BEACON PLANNING BOARD
Via Video-Conference
BEACON, NEW YORK 12508
Phone (845) 838-5002 Fax (845) 838-5026

Beacon Views - Conklin Street

Continue public hearing for SEQRA environmental review on applications for Subdivision and Site Plan Approval, "Beacon Views Townhouses" 40 units, Conklin Street, submitted by Beacon Views, LLC

RE: Beacon Views Site Plan and Conservation Subdivision
Conklin Street
Beacon, New York
Tax Parcel ID: 6055-03-331123

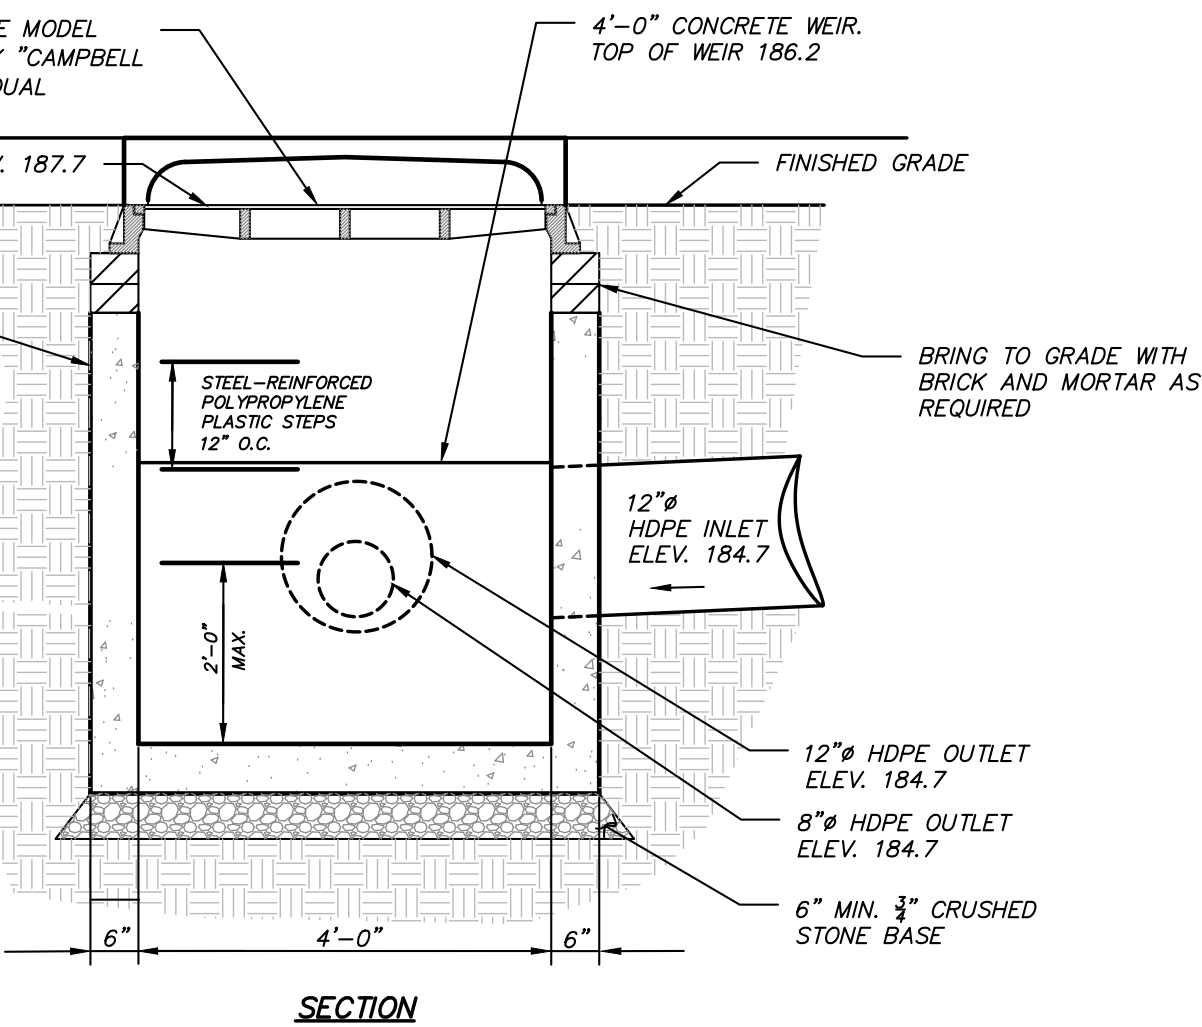
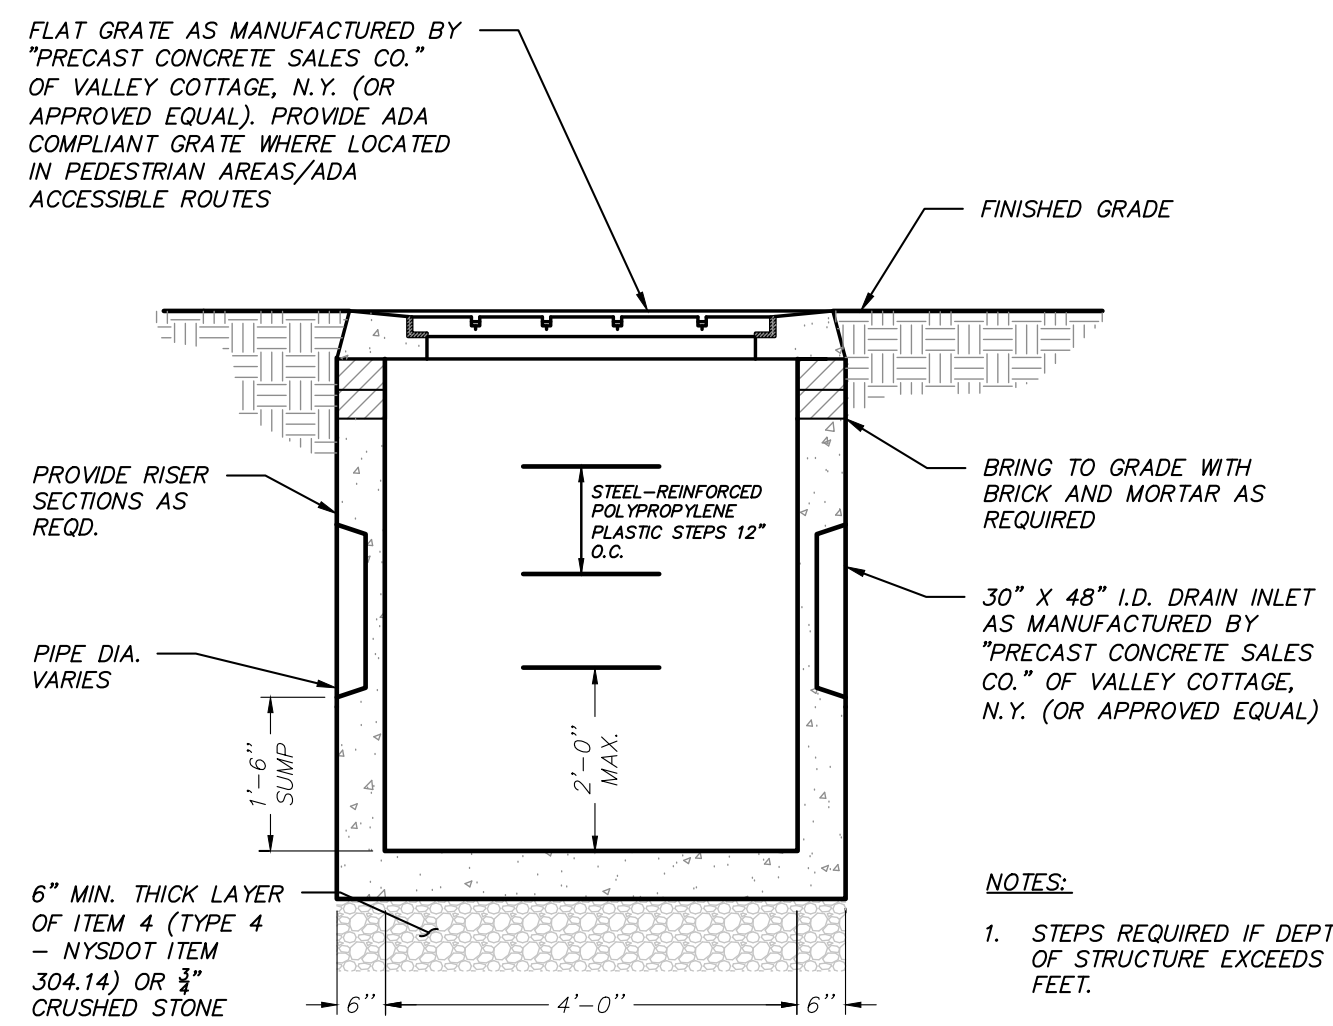
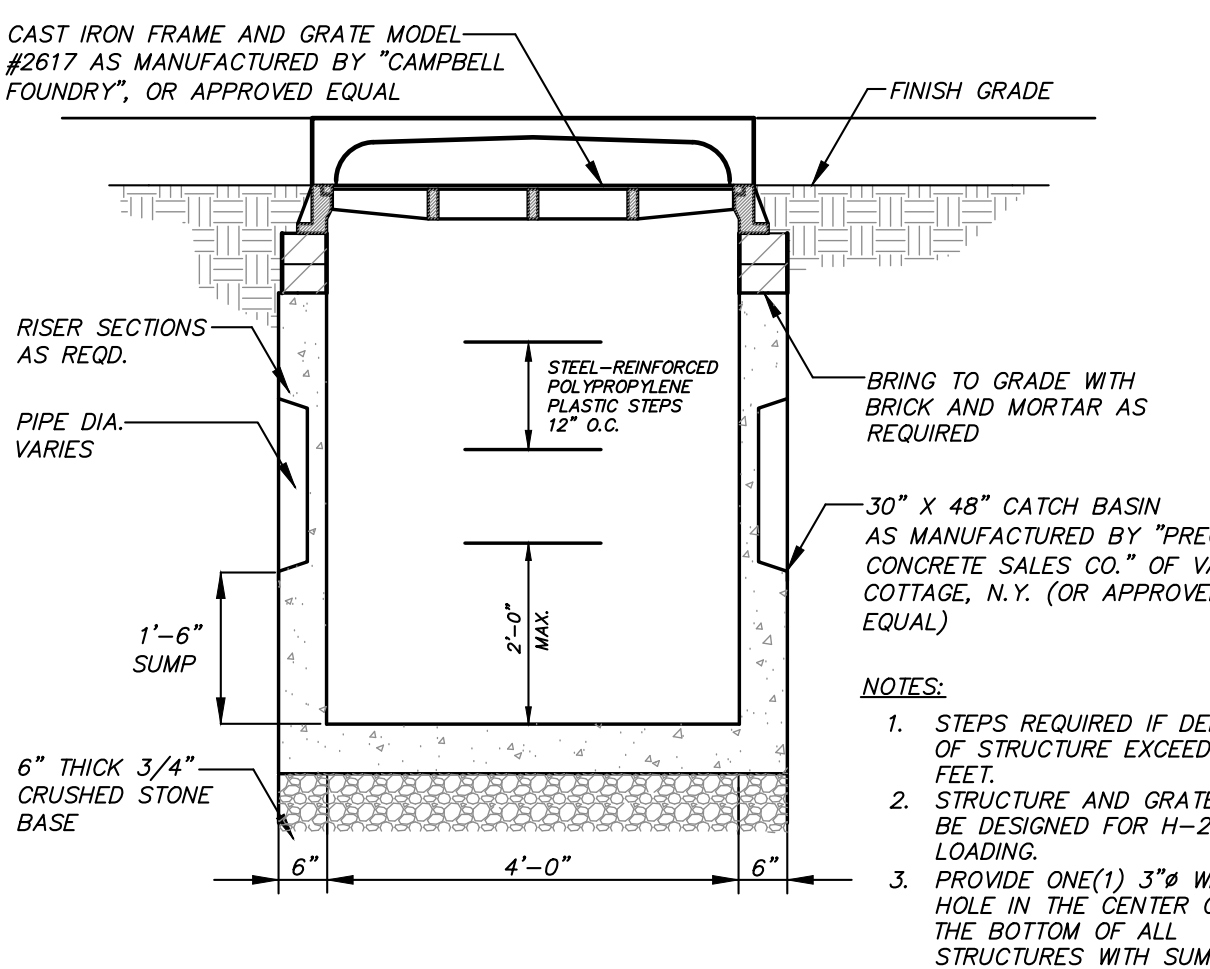
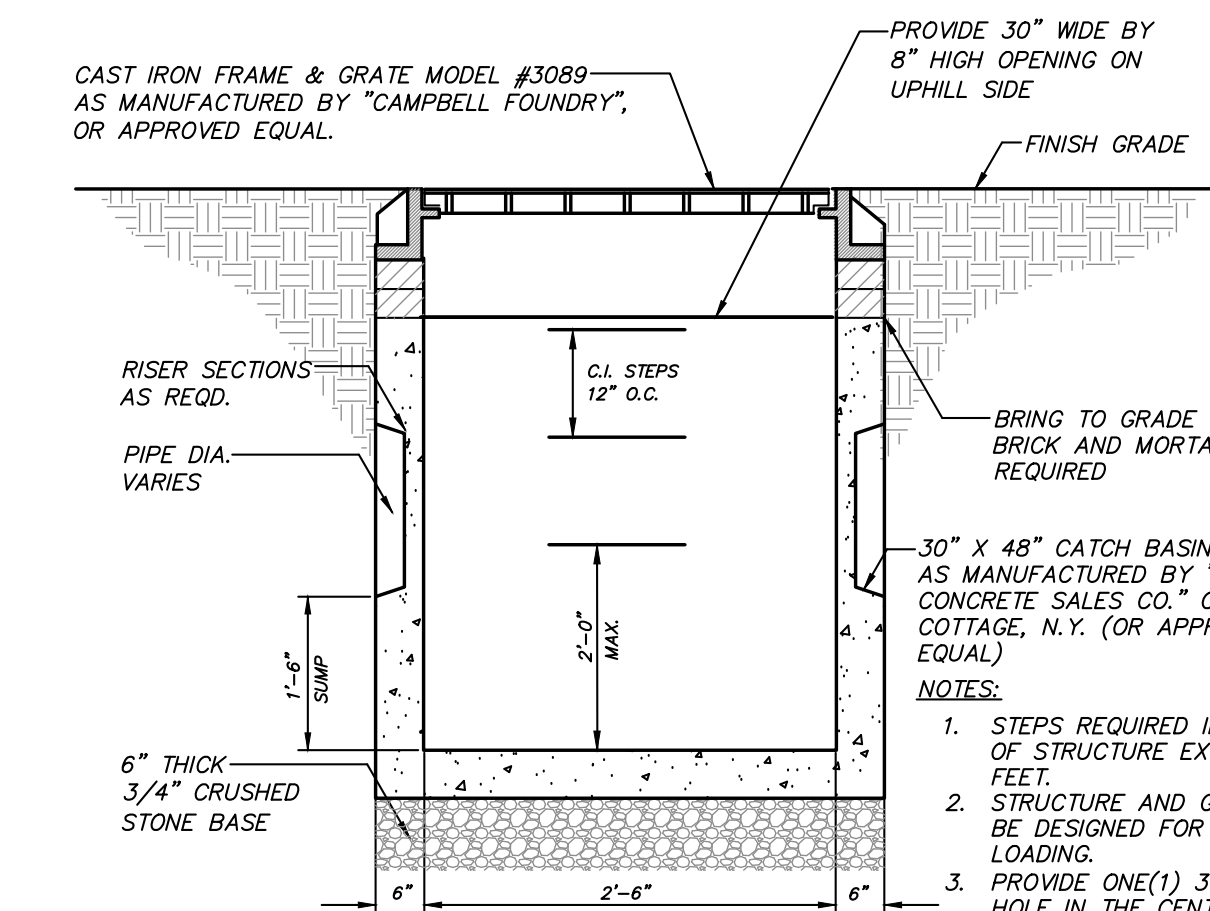
1. The requested note regarding manhole and catch basin castings has been added to all applicable details.

NOTE: ALL MANHOLE CASTINGS AND CATCH BASIN CASTINGS ARE TO BE DOMESTICALLY MADE FOR ANY STRUCTURE LOCATED WITHIN THE CITY RIGHT-OF-WAY, OR TO BE DEDICATED TO THE CITY.
